WALLARAH 2 COAL PROJECT

Amendment to DA SSD-4974 Response to DP&E

**WALLARAH 2 COAL PROJECT
AMENDMENT TO
DEVELOPMENT APPLICATION SSD-4974**

**RESPONSE TO DEPARTMENT OF
PLANNING & ENVIRONMENT**

Figure 1 Time Series of Simulated Flow Lower Wyong River Weir

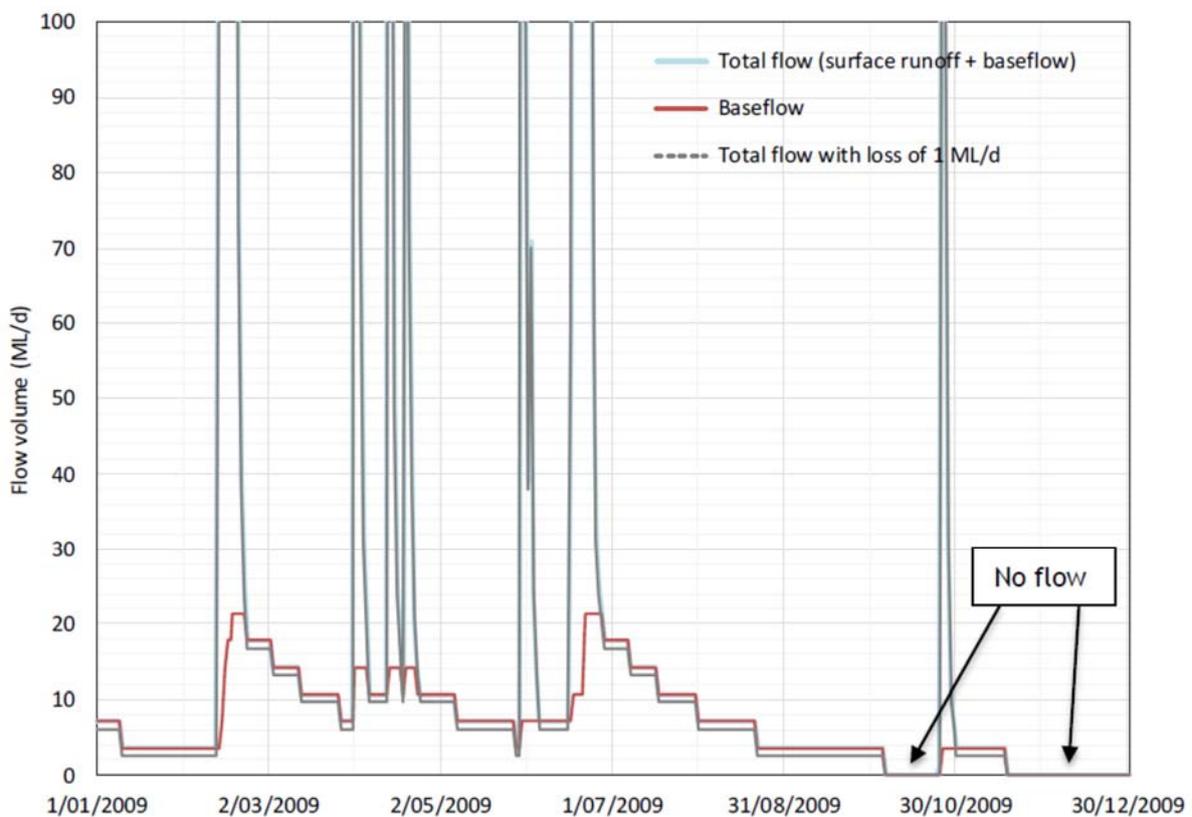
It would be useful to gain an understanding of stream flows vs baseflows in periods of low flows and their respective quantitative amounts. In addition, the Department notes the predicted loss of 300 ML/Y of baseflow during average years. What consequence would this loss have on the CCWS during periods of low flow?

WRM has undertaken a further analysis to illustrate the impact of potential "worst case" water loss on both surface runoff and baseflow in the Wyong River catchment. The model was used to simulate the runoff and baseflow components of the catchment drainage to the Lower Wyong River Weir for two scenarios (for each of a dry year and very day year) under:

As shown in **Figure 1** in a dry year, the impact on flows is negligible during periods of surface runoff. The impact of flow loss during dry periods is apparent, but does not change the general character of flow which typically persists for an extended period after surface runoff, with some no-flow periods after extended dry weather. Within the resolution of the model, the impact on the number of no-flow days is **negligible**. In practical terms, it is unlikely that this flow volume loss could be detected.

Under a very dry year the total flow volume reduces by approximately 8%. Again, based on the model resolution, the impact on the number of no-flow days is **negligible**. In practical terms, it is unlikely that this flow volume loss (which represents an upper limit of potential impacts) could be detected.

Plate 1
Property Access Road Requirements (Rural Areas)

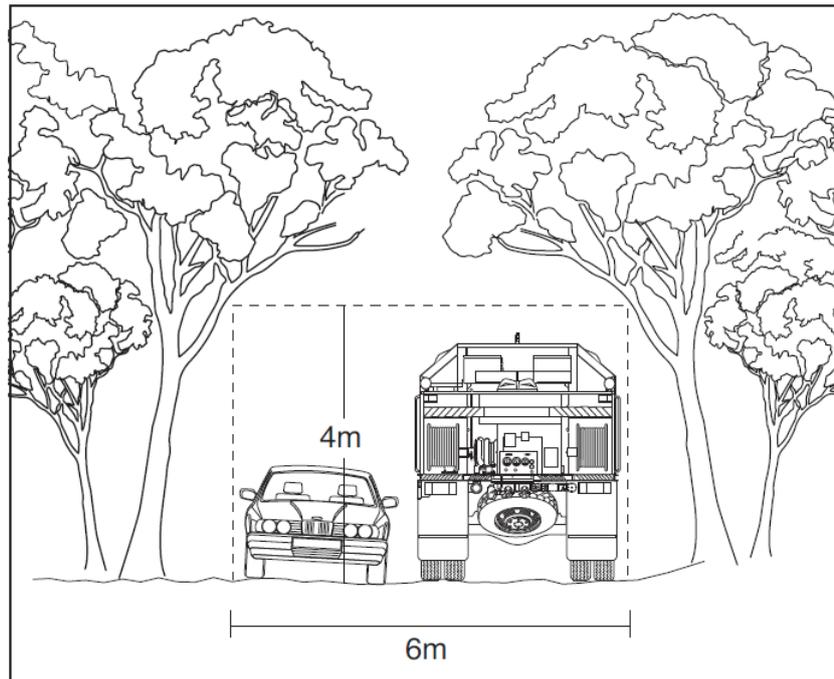
13. *The WACJV Response does not adequately address the issue of bushfire risk or the need of the project design to have regard to basic standards. The coal loading facility if proposed in bushfire prone land and immediately adjacent to Category 1 Vegetation without any setbacks or "Asset Protections Zones". The project will be contained in a 20m corridor with the eastern side of the coal loader immediately adjacent to the canopy of the adjoining bushland. The 6 m access road will in some sections be fenced on one side. There is no room for appropriate turn around bays for emergency vehicles. It is not a defensible space in the event of a fire and will be fire trap.*

The 6m wide road does not require additional passing bays and is consistent with '*Planning for Bush Fire Protection 2006*' Figure 4.5 (reproduced as **Plate 1**). The conveyor design has adequate space to have compliant fire-fighting infrastructure (i.e. reticulated water supply, hydrants and fire depots) providing a fire fighting capability for RFS well in excess of that currently provided by tanker trucks.

Figure 5 Conceptual Area Available for Parking at Nikko Road

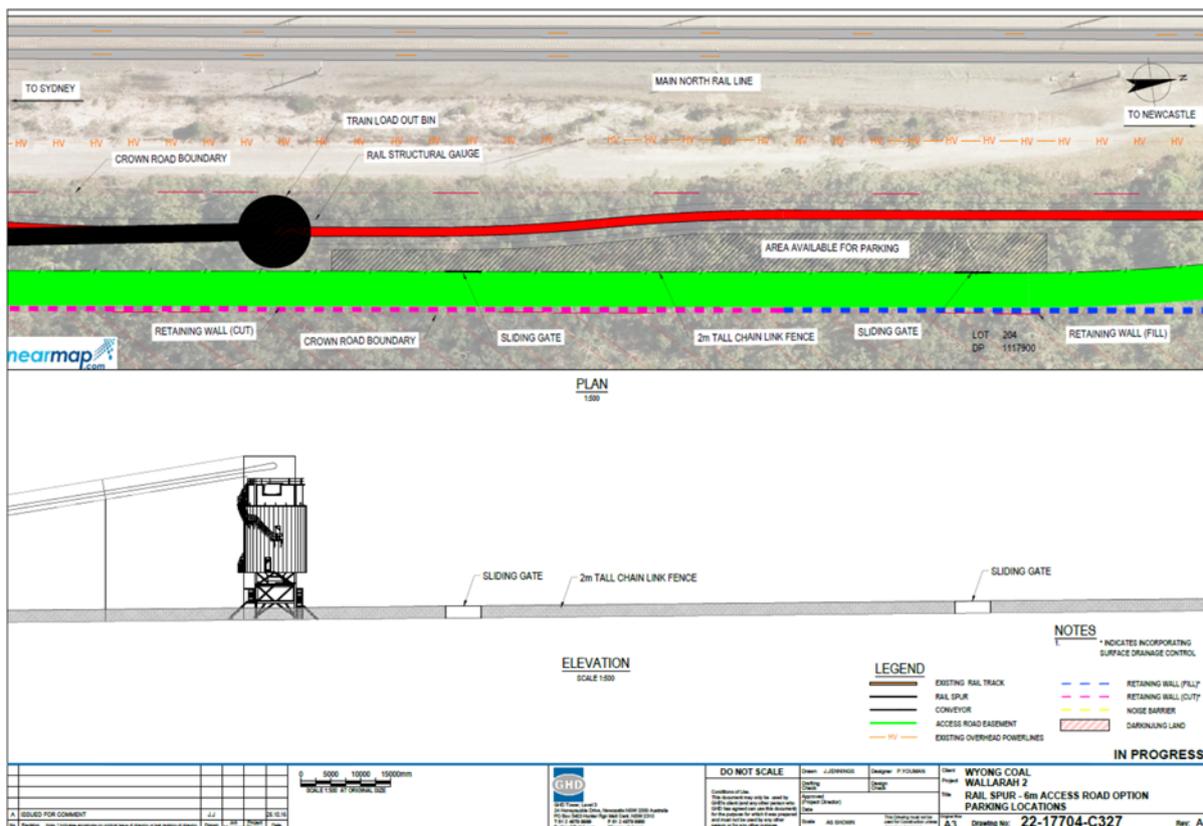
36. WACJV does not clarify how parking on Nikko Road would operate in such a narrow corridor.
37. The response in the Amendment RTS ignores the issue. There must be some spaces for parking, even if intermittently. Furthermore, larger vehicles for maintenance and emergency vehicle should have sufficient space, especially when being shared with the public.

Preliminary measurements include a 3 m wide train with a 2 m clearance from fences either side (totalling 7 m) and a 6 m wide access road with a 1 m eastern side buffer with drainage control structures (totalling 7 m).

With 14 m of the road being utilised for rail and access purposes, an approximate 6 m width area located centrally at the northern end of Nikko road is available for parking (when required) and service vehicle access as conceptually shown in **Figure 5**.

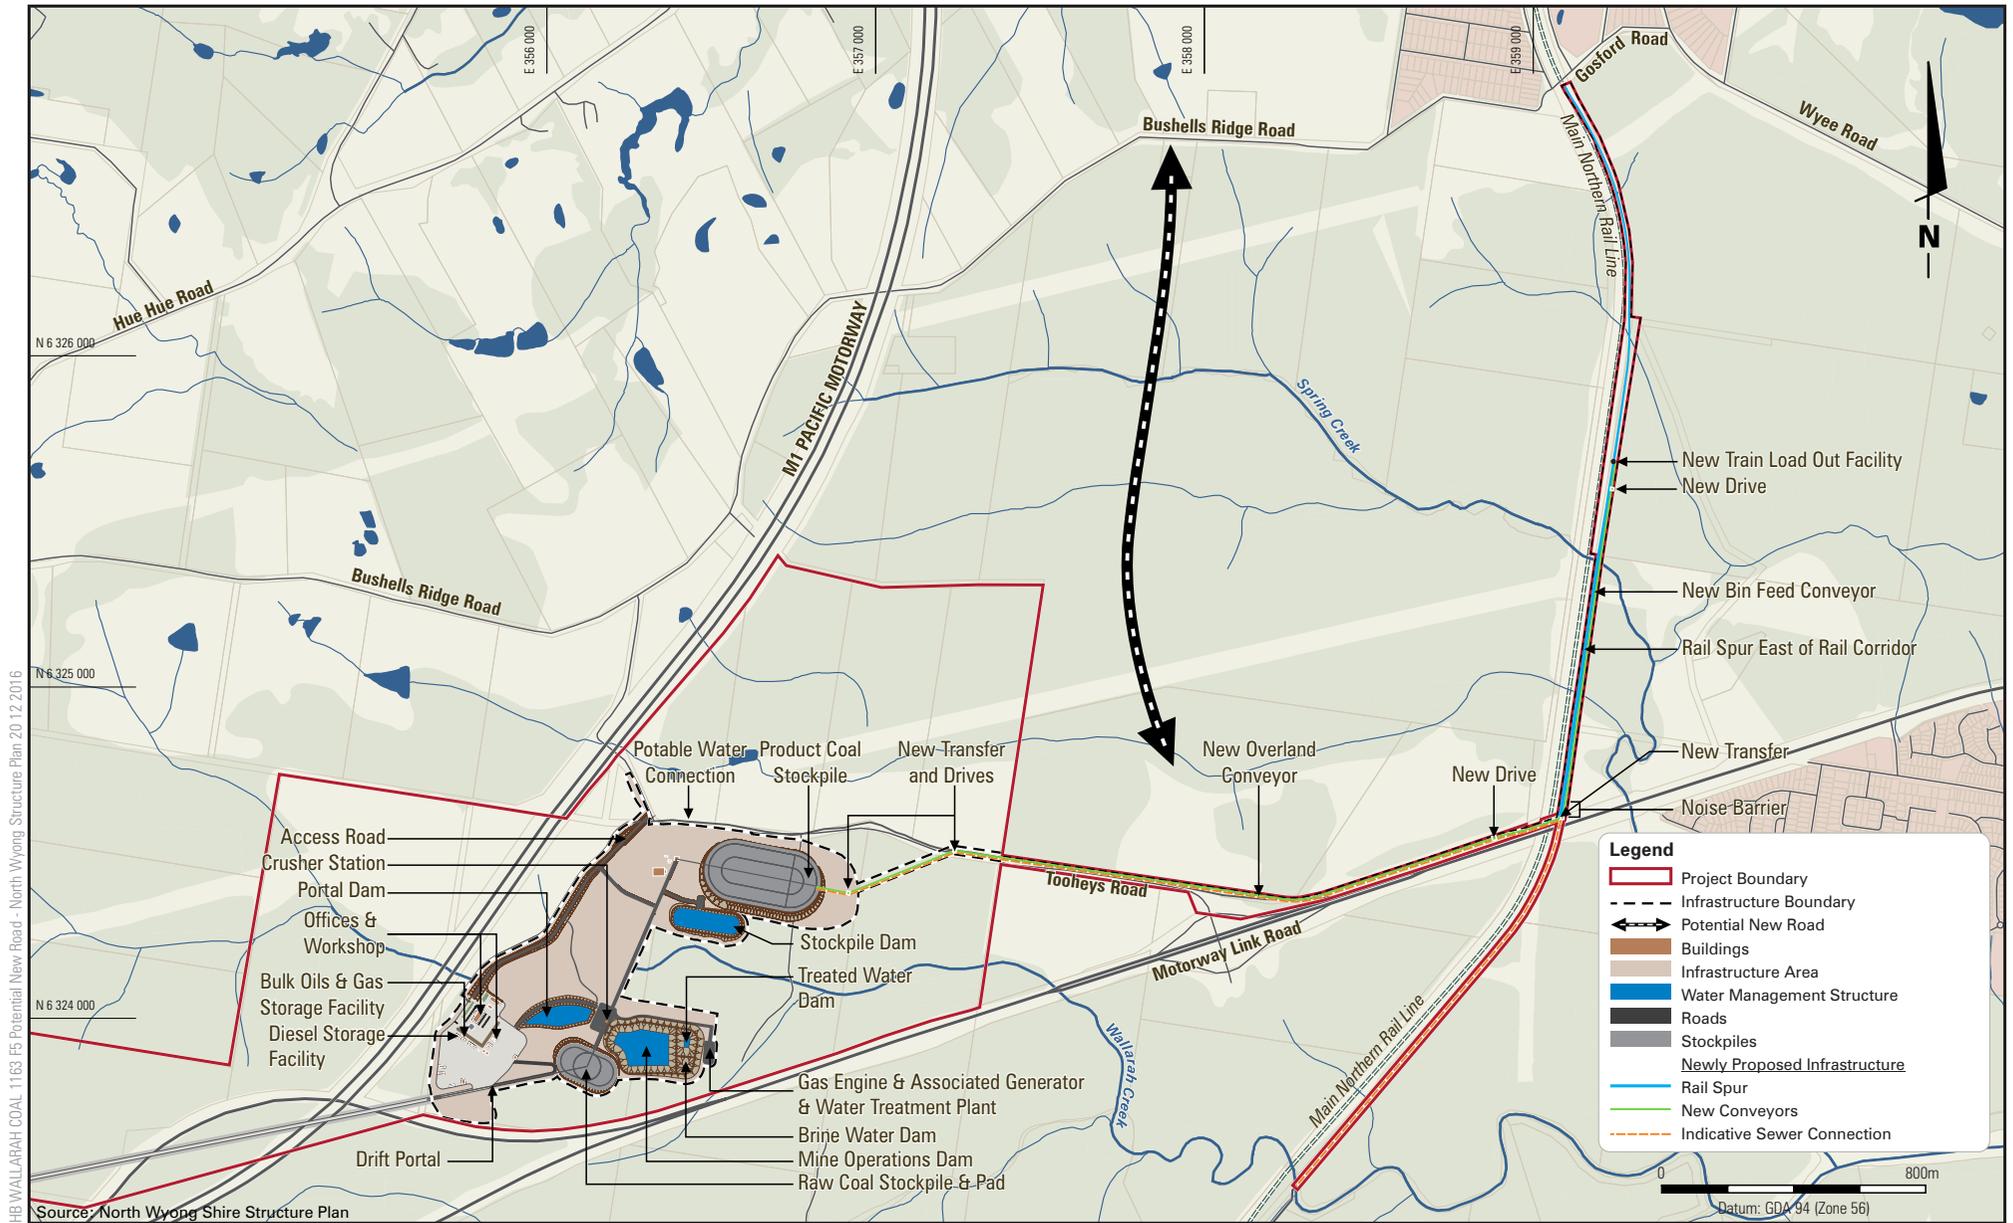
56. *The Amended Application, particularly the closure of Nikko Road reserve will deny the potential for a strategic road corridor linking the growing towns of Wyee and Warnervale. WACJV states the future need of this road reserve has not been identified in the Central Coast Regional Plan (CCRP) (2016). Closer examination of the North Wyong Shire Structure Plan 2012 (NWSP) reveals that potential new roads have been identified linking Wyee to the northern end of Wyong Shire (and also from Watanobbi towards the Warnervale Town Centre).*
57. *Prior actions of the CCRP including working with DLALC and Council to strategically assess its land holdings to identify priority sites and create a pipeline of potential projects and incorporate the assessment of DLALC landholdings into a revised North Wyong Shire Structure Plan. The Amended DA does not site comfortably with these priority actions.*

Figure 6 digitises the “Potential New Roads (subject to further planning and funding)” in the vicinity of the Amended Project from map 2 from the NWSP. It does not align with Nikko Road and is conceptually located running north-south approximately 1 km to the west of the Main Northern Rail Line. Nikko Road is not discussed in the NWSP.

The Amended DA is not contrary to the potential new road in the vicinity as shown on map 2.

ADDENDUM 1: RTS (FIGURE 17)

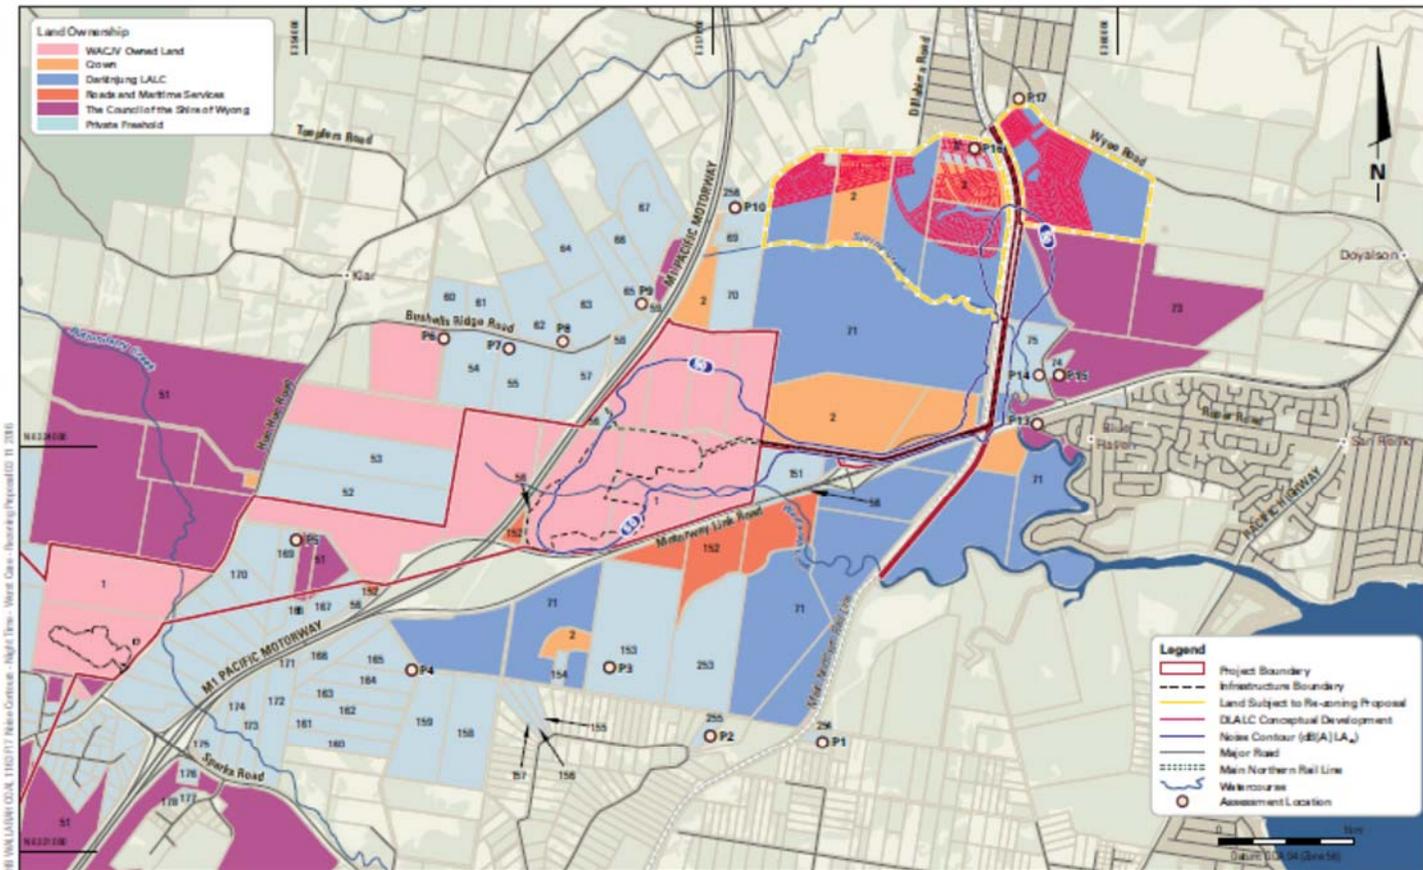
It is noted that the assessment of potential noise impacts in the RTS is based on its Figure 17 which shows worst case noise contours as $dB(A), L_{Aeq}$. It is evident from the assessment in AA0716 that these contours are for worst-case 15 minute periods when a train is being loaded and the loading facility is fully operational. The noise level averaged over a full night time period will include periods of little or no noise and will be significantly lower than the level considered in the assessment of impacts under VLAMP Category 5, resulting in a lesser degree of impact. Categories 3 and 4 are relative to intrusiveness ($L_{Aeq,(15minute)}$) criteria, however, and the assessment of impacts in Table 2 remains valid, subject to model confirmation of the number of impacted Lots.

- 26.0 SA refers to the RTS (Figure 17) to reproduce SA Figure 1. Reviewing the SA noise contours it appears that the information was extracted from the Addendum Noise and Vibration Report (reproduced below at Addendum 2) not Figure 17 from the RTS (reproduced below at Addendum 1).

- 30.0 Reviewing the $L_{Aeq, 15min}$ adjustment assuming three coal trains per night (-3dBA), the predicted $L_{Aeq, 9\ hour}$ 50dBA contour would not occur on any Darkinjung land shown on RTS Figure 17 (Addendum 1). This further demonstrates the conservative approach to noise modelling applied to the Amended Project.
